## Restaurant Details- QUIQUE CRUDO (20240417010003)

Re: **Establishment Reviewed:** Quique Crudo  
27 Bedford Street  
Manhattan, NY 10014

**Roadway Cafe Site Plan Form**

Applicant Name: CE 27 LLC  
 Restaurant Name: QUIQUE CRUDO  
 FSEP Number: 50139570

**SECTION 1: Site Plan**

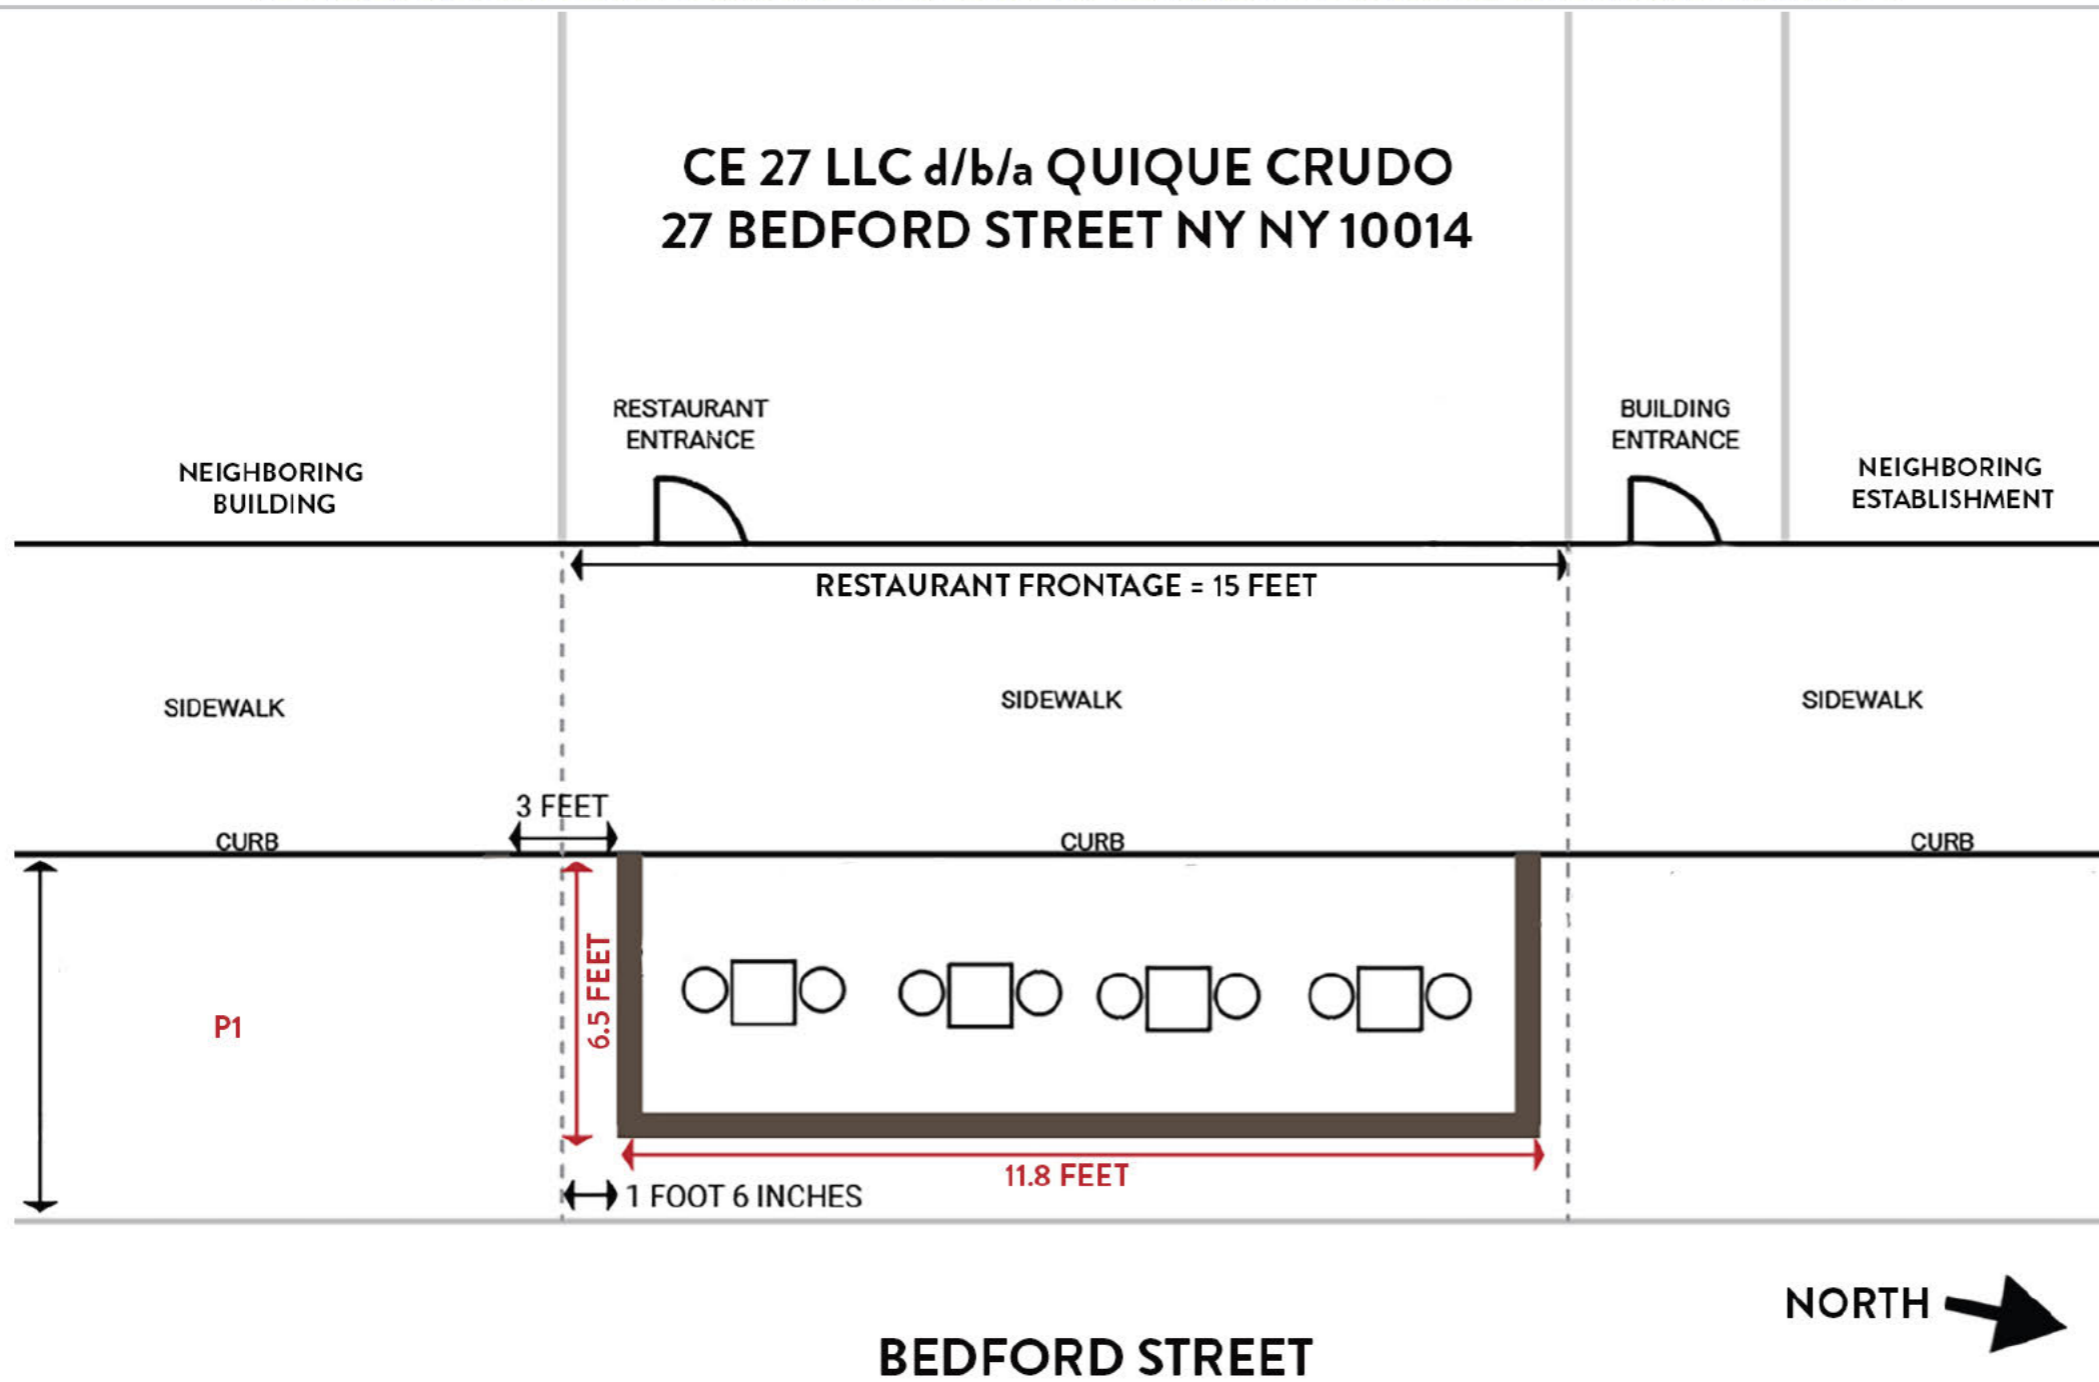
- The roadway is approximately 25' wide (curb to curb).
  - The applicant is proposing a structure that is 6.5' wide.
  - The existing parking lanes are 8' wide.
  - If implemented, the emergency travel lane remaining would be 10.5' wide.

<u>Criteria from memo: NYCDOT's Dining Out NYC Program</u>	<u>FDNY City Planning Comments</u>
1.1 The FDNY does not encourage the implementation of such variances (Roadway Cafés that propose reducing the emergency travel lane width to less than 15'.	The proposed Roadway Café would reduce the emergency travel lane to 10.5'.

Bedford Street between Downing Street and 6<sup>th</sup> Avenue provides for a narrow emergency travel lane. The proposed Roadway Café presents an obstruction having potential to negatively impact Fire Operations. However, the FDNY Bureau of Operations has determined the potential impact as minimal, and therefore, with coordination with local units, has **no objection** to implementation. Applicant is required to contact Battalion 2, Engine 24, Ladder 5, ([bat002@fdny.nyc.gov](mailto:bat002@fdny.nyc.gov), [eng024@fdny.nyc.gov](mailto:eng024@fdny.nyc.gov), [lad005@fdny.nyc.gov](mailto:lad005@fdny.nyc.gov)) prior to occupancy of the Roadway Café to provide familiarization. Considerations offered by the Administrative Company shall be applied to the approved Roadway Café as deemed necessary.
